## TECHNICAL SERVICE BULLETIN

**Subject:** TSB FOR ECN# 10641- KIT/FLD RADIATOR MOUNT P/N 3336801

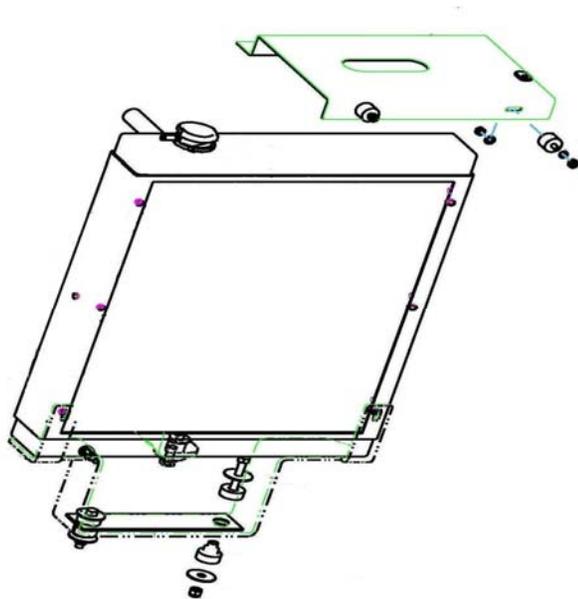
THIS WILL REDUCE THE FLEXING AND EXTEND THE SERVICE LIFE OF THE RADIATOR.

THE NEW BRACE DESIGN WILL ADD RUBBER ISOLATORS WHICH WILL LIMIT THE FLEXING OF THE RADIATOR.

**Reference Kit Instructions** –THE KIT PART NUMBER **3336801** WILL ADD NEW BRACKETS AND RUBBER ISOLATORS. THE RADIATOR IS INCLUDED IN THE KIT.
